Access Compliance Report

Public Rights-of-Way

(Curb Ramps)

Intersection ID: 8203	Main Street: HONEYWOOD_AV	Cross Street: TENNESSEE_AV	Location: S
ADA ID: 05127FA3CFA1	Ramp Type: Perp	Initial Pass/Fail: Fail	Overall Compliance: No
Severity Score: 10			
Codes/Mitigation Info/Possible Solution		Field Measurements/Component Compliance

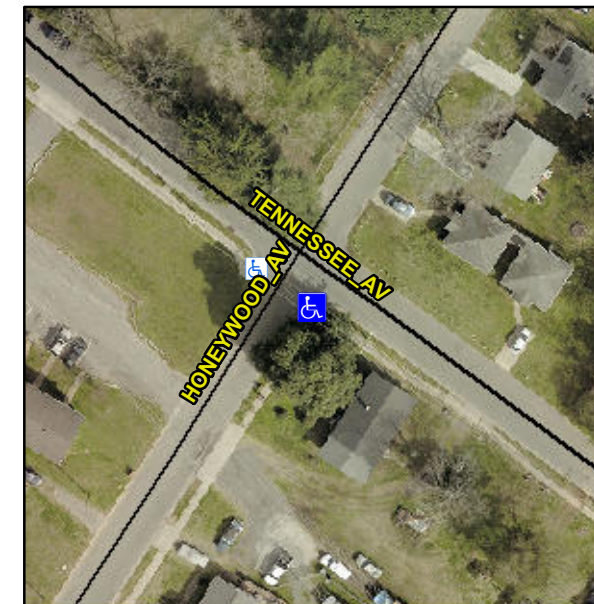
Not Found, R304.5.1, R304.5.3

Compliance	Description	Data	Compliance	Description	Data
N/A	Ramp Length (in)	48.0	Yes	Ramp Slope (%)	6.2
No	Ramp Width (in)	47.5	No	Ramp XSlope (%)	2.6
N/A	Flare Type LT	N/A	N/A	Flare Type RT	N/A
N/A	Flare Slope LT (%)	N/A	N/A	Flare Slope RT (%)	N/A
N/A	Flare Traversable LT?	N/A	N/A	Flare Traversable RT?	N/A
N/A	Landing Length (in)	N/A	N/A	DWS Provided?	N/A
N/A	Landing Width (in)	N/A	N/A	DWS Contrast?	N/A
N/A	Landing Slope (%)	N/A	N/A	DWS Length (in)	N/A
N/A	Landing X Slope (%)	N/A	N/A	DWS Full Width?	N/A
N/A	Landing Curb? (Y/N)	N/A	N/A	DWS Offset (in)	N/A
N/A	Shared Landing?	N/A			
N/A	Gutter Ponding?	N/A	N/A	Gutter Slope (%)	N/A
N/A	Gutter Lip Ht (in)	N/A	N/A	Gutter X Slope (%)	N/A
N/A	Painted X Walk1?	No	N/A	Painted X Walk2?	N/A
	X Walk 1 Direction	To NW		X Walk 2 Direction	N/A
N/A	X Walk 1 Width (in)	N/A	N/A	X Walk 2 Width (in)	N/A
	X Walk 1 Slope (%)	2.1		X Walk 2 Slope (%)	N/A
	X Walk 1 X Slope (%)	0.2		X Walk 2 X Slope (%)	N/A

Remove & Replace Entire Ramp.
